August 24, 2001

Refer to: HSA-10/CC46D

In your May 18 letter, you described a FLEAT guardrail terminal modified for use with a strong post, w-beam guardrail median barrier and provided preliminary summary information on the tests that were run at Southwest Research Institute to verify its compliance with current evaluation criteria. You also included a videotape of the tests that were conducted. Mr. Richard Powers of my staff received single copies of the final reports, entitled "FULL-SCALE CRASH EVALUATION of a FLEAT MEDIAN TERMINAL SYSTEM", TESTS FMT-1, FMT-2, and FMT-3M on August 22.

**Flared Energy Absorbing Terminal
FEAT Median Assembly For
Steel Breakaway Post System**

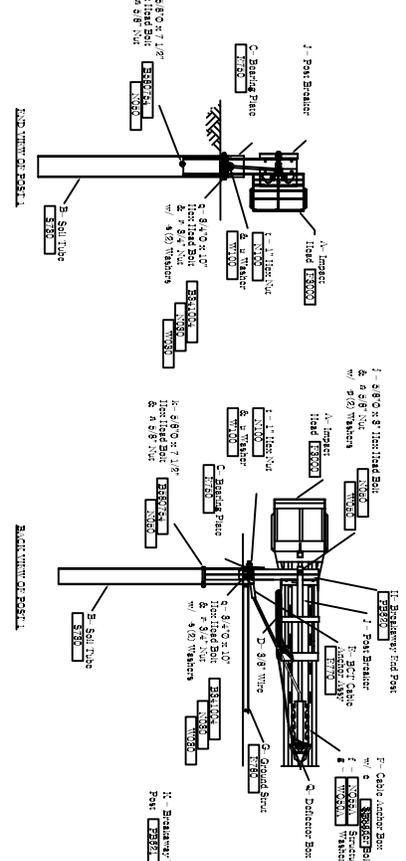
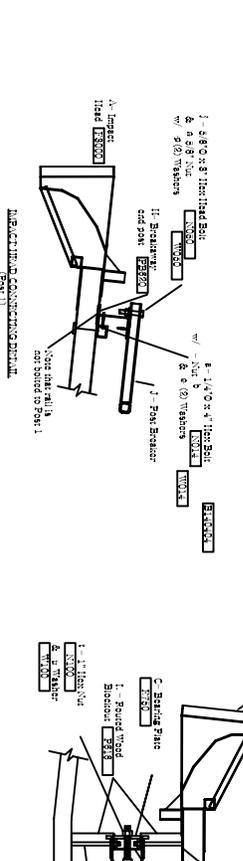
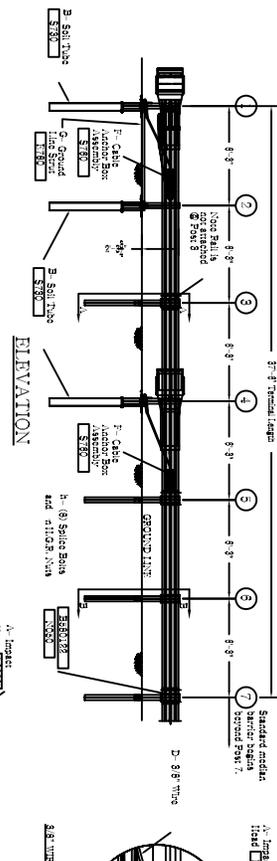
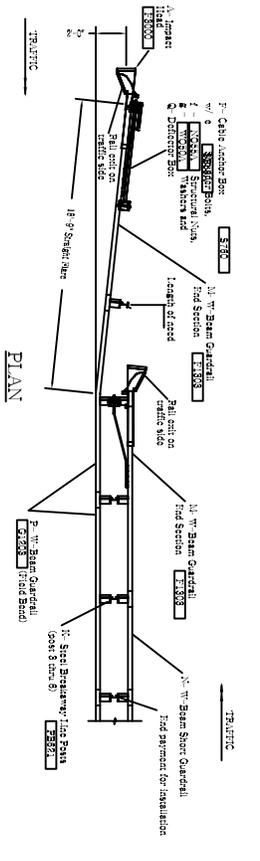
As seen in Enclosure 1, the FLEAT-MT is nearly identical to the previously accepted FLEAT roadside terminal. Since its intended use is to terminate a double-faced, strong post w-beam median barrier, two impact heads are required. One of these is at the fourth post in from the end of the barrier and fits over the backside w-beam rail element. The other impact head fits over the end of the traffic-side rail element 5717 mm ahead of the first and is offset 610 mm from the face of the median barrier proper in a straight flare. Minor modifications were made to the design to obtain satisfactory results in the reverse direction impact described below.

Based on the similarity of the FLEAT-MT to the roadside FLEAT design and layout, you reviewed the tests upon which acceptance of the FLEAT was based and concluded that only three additional tests would be required to certify the median terminal under NCHRP Report 350. My staff concurred with your analysis. The first test conducted was NCHRP Report 350 test 3-35, the 2000-kg pickup truck redirection test. The truck impacted the terminal at post 3, the beginning of the length of need, at 100.4 km/h and 20.8 degrees. Although all evaluation criteria were satisfied, the test vehicle snagged on post 7, which was a standard steel line post. This result was discussed with your consultant, Dr. Dean Sicking, and it was decided to make post 7 a breakaway design to improve test performance. This change is not reflected in the test reports, but is shown in Enclosure 1.

The final test was NCHRP Report 350 test 3-39, the reverse-direction impact that is required for devices such as median barrier terminals that are likely to be struck from either direction. When this test was first run, the pickup truck snagged on the downstream cable anchor and subsequently overturned. When a deflector bracket was added to the downstream end of the cable anchor, the vehicle was successfully redirected and all evaluation criteria were satisfied.

Based on the information you presented, I agree that the FLEAT-MT, as shown in Enclosure 1, meets the NCHRP Report 350 evaluation criteria for a test level 3 (TL-3) terminal and may be used on the National Highway System (NHS) to terminate a w-beam median barrier when such use is accepted or specified by the appropriate contracting agency. As a proprietary product, the conditions listed in Title 23, Code of Federal Regulations, Section 435.411 apply to its use on Federal-aid projects located on the NHS.
